Advocates for the Tongariro River – Feedback on 2023/24 Annual Works Programme

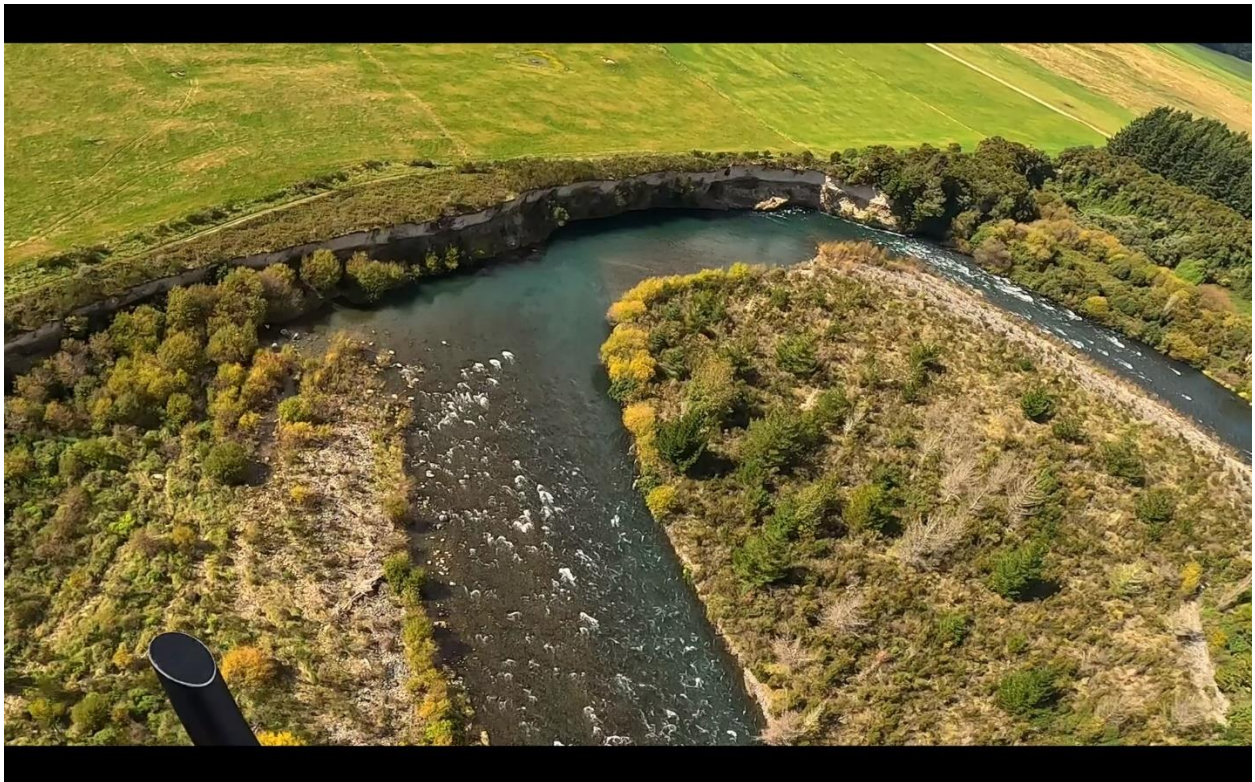
Woody Vegetation not addressed in 2023-24 Plan.

Juvenile Pine, Willow, and Broom below SH1 Bridge

Island Pool Broom Forest

3M High Broom Jungle

5M High Willows

Wilding Pines toppling into river – Island Pool

Willow growth at Reed Pool

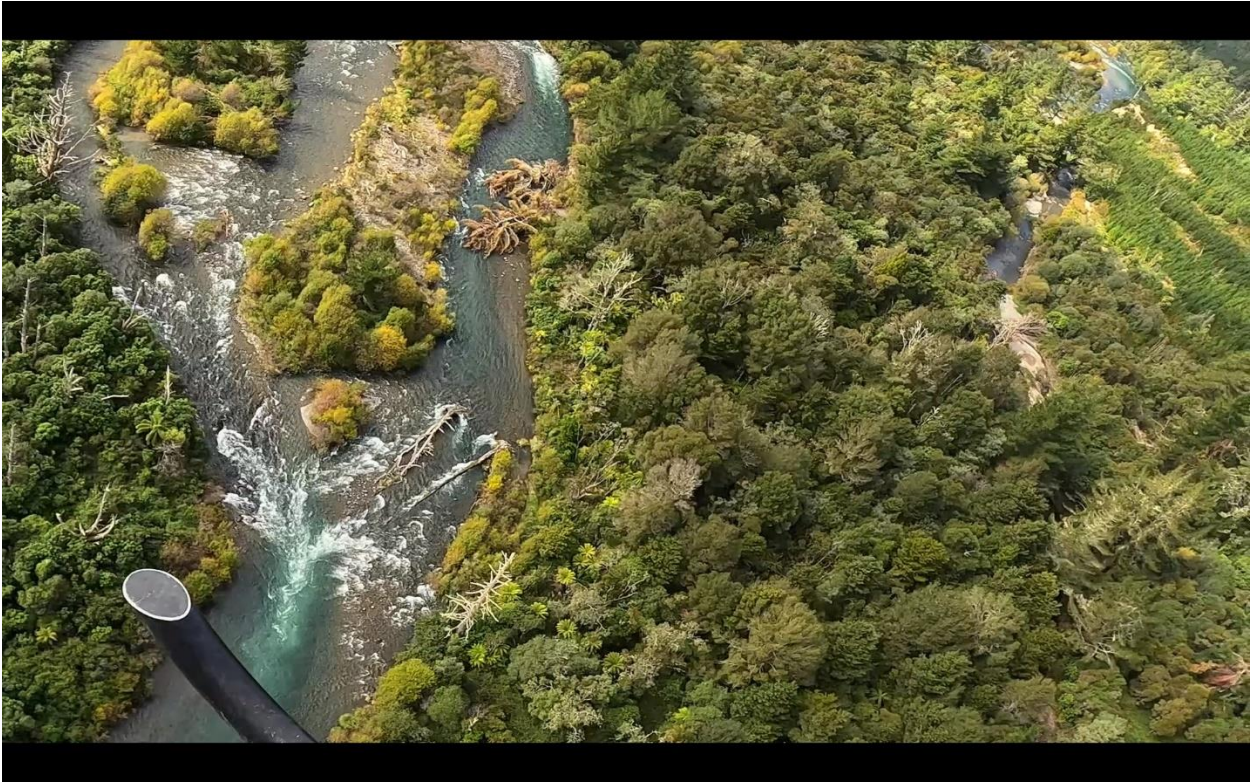
PROBLEMS TO COME FROM ABOVE THE FLOOD PLAN SCHEME

Wilding Pines above Admirals Pool in flood path.

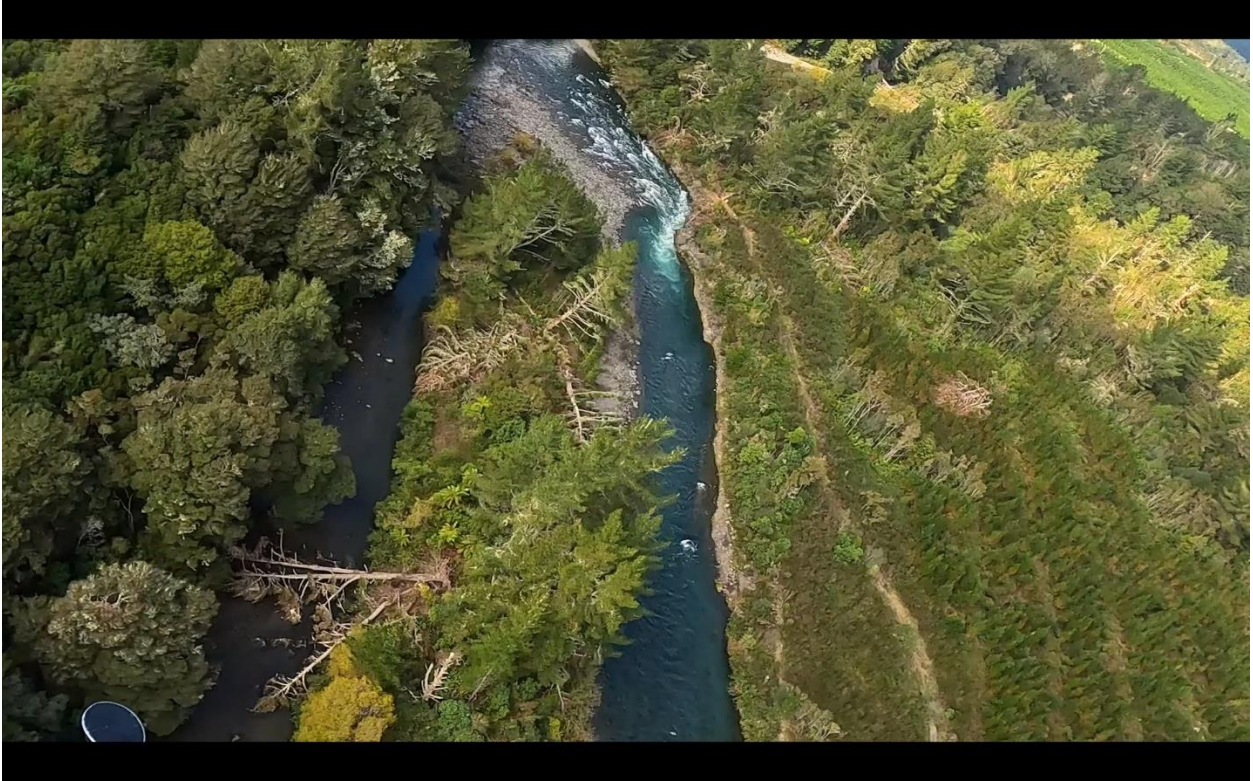
Wilding Pines on island above Duchess Pool

Fallen Pines above Poutu Pool
